RIO GRANDE BASIN
SOHIO L-BAR
TAILINGS DAM

PHASE I INSPECTION REPORT

PREPARED BY: TIERRA ENGINEERING
CONSULTANTS INC.

FOR: U.S. ARMY CORPS OF ENGINEERS & THE
STATE OF NEW MEXICO
AUGUST, 1979

PHOTO 2 - VIEW OF DOWNSTREAM SLOPE FROM NORTH END LOOKING SOUTH. NOTE STARFF DAM AND STAGE 1 LIFT OF TAILINGS DIKES.

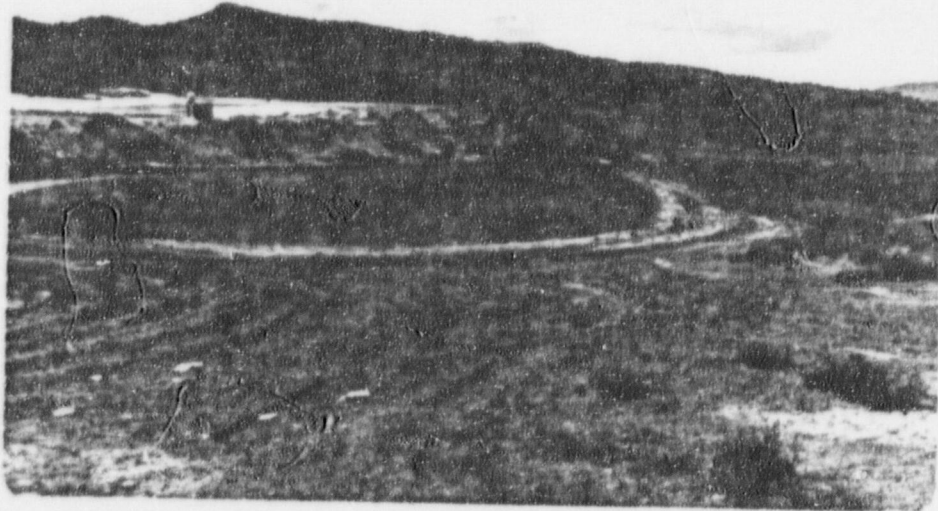
(1) Crest. Construction of the first tailings dam above the starter dam has been completed. The dam was raised using tailings in the immediate vicinity of the crest. See photos 2, 7, 8 and 9, Appendix F. The crest is backed by a sand tailings beach of several hundred feet, however, at the time of the inspection, tailings were being discharged immediately adjacent to the crest. If tailings are dumped next to the crest and have no access to the main pool, then the slimes also settle near the crest and provide a layer of weak material underlying future raises of the dam.

a. Crest. The crest requires repairs to assure its stability. Sloughed areas should be filled and the seepage discharge faces should be armored, filtered or otherwise designed and constructed to provide a controlled discharge for seepage waters. Emerging seepage waters should be gathered and conveyed to a safe discharge point. The downstream slope and crest should be constructed to the configuration suggested by the consultant in the Woodward-Clevenger report and as presented in the plans shown in Appendix A. Adequate freeboard should be maintained and borrow for future raises obtained in a manner that allows drainage to reach the pond area.

PHOTO 20 - VIEW OF SOUTH DIVERSION CHANNEL LOOKING FROM SOUTH TO NORTH.

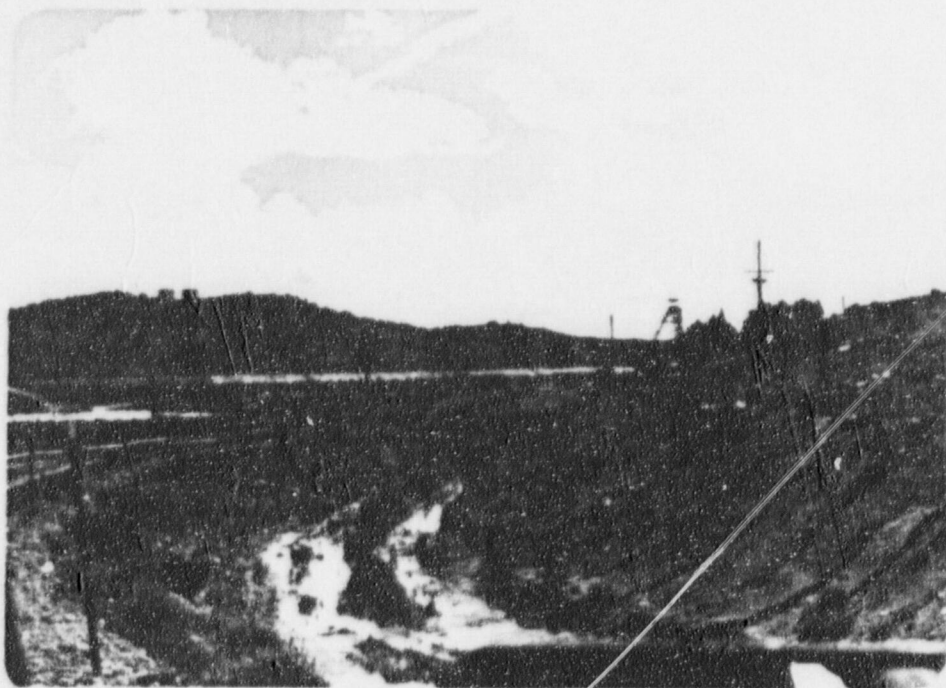
(3) Upstream Diversion Channels. The upstream diversion channels are not designed to carry the flows required by Corps of Engineer's criteria for dam evaluation. The channels have stated capacity of 280 C.F.S. and 840 C.F.S. The Corps' criteria indicates a Probable Maximum Flood (PMF) of 388 C.F.S. and 2000 C.F.S. from the north and south watersheds respectively. The Corps' values were obtained using the chart labeled "Maximum Experienced Peak Discharges" presented in Appendix C. The channels are in good condition with no noted blockages. Photos 20 and 21, Appendix F, show the south channel.

c. Upstream Diversion Channels. The carrying capacity and configuration of diversion channels should be evaluated and upgraded to provide safe discharge of upstream flood water.

PHOTO 35 - VIEW OF CRACKING ON DOWNSTREAM SLOPE APPROXIMATELY
HALFWAY UP EMBANKMENT.

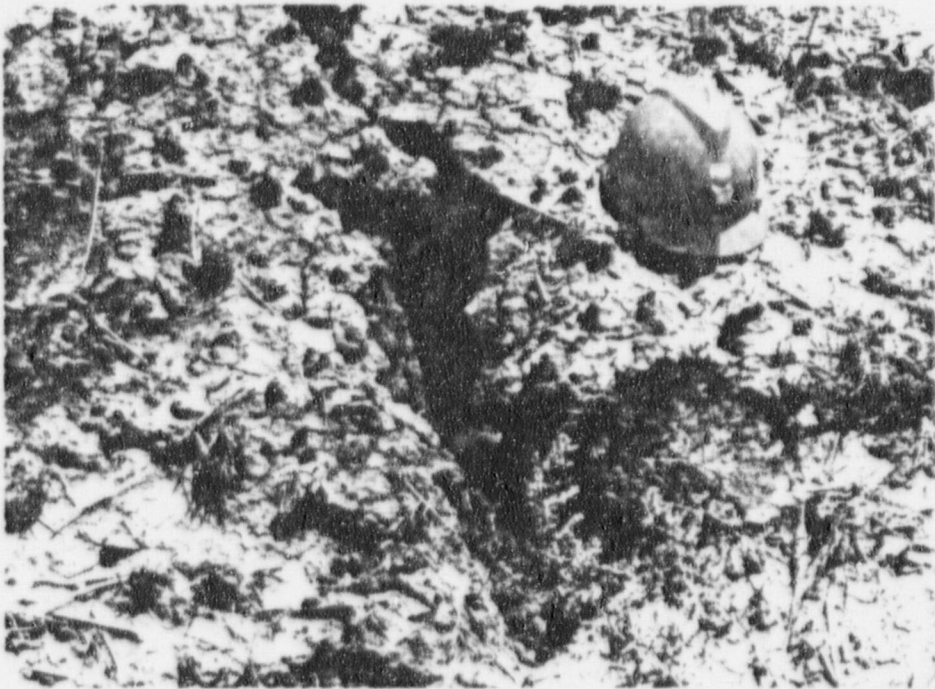
Cracks were noted on downstream face of the starter dam starting approximately 100 feet from the piezometer line and continuing 200 feet north. These cracks run downstream on the face and seem to be concentrated mostly mid-way on the dam. The largest crack is about 6 inches wide, perhaps more than 2 feet to 3 feet deep and approximately 10 feet to 15 feet long. See photo 35, Appendix F.

PHOTO 43 - VIEW OF ANIMAL BURROW.

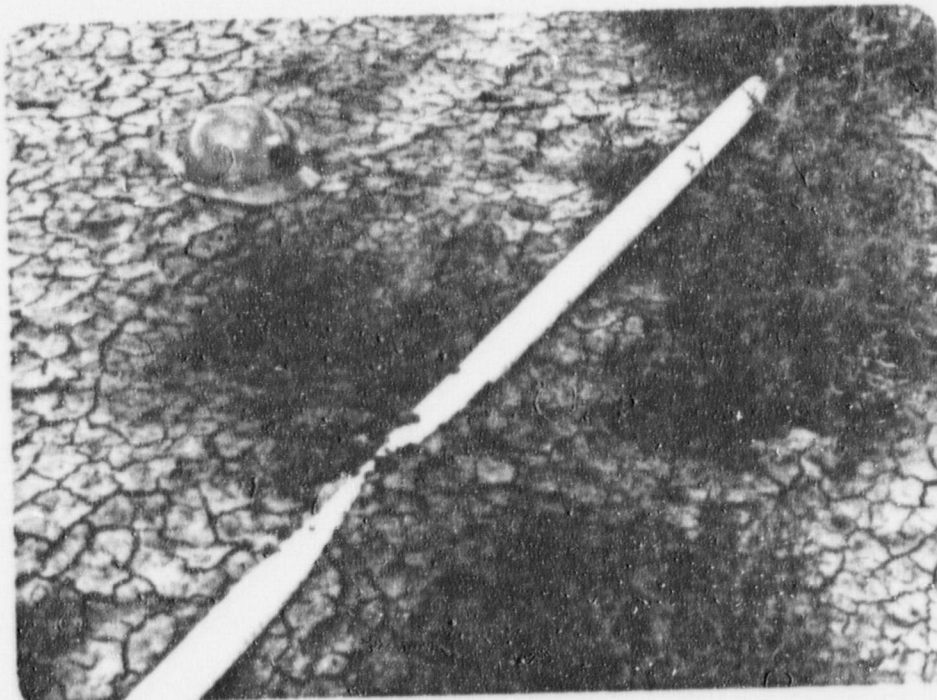
(5) Saddle Dam. The saddle dam appears to be in good condition except for rodent activity and the apparent reaction of solution waters with the earth dam or foundation at the upstream (west) toe. This is evidenced by bubbling and scum on the surface. Rodent activity was present at all levels of the dam from the crest to the downstream toe, however, most of the burrows were located near the downstream toe to about the mid-height of the dam. See photos 40 through 43, Appendix F, for the saddle dam.

d. Saddle Dam. The saddle dam requires maintenance to fill rodent holes and eliminate the burrowing animals. The dispersive soil study required for the starter dam should be applied to the saddle dam also.
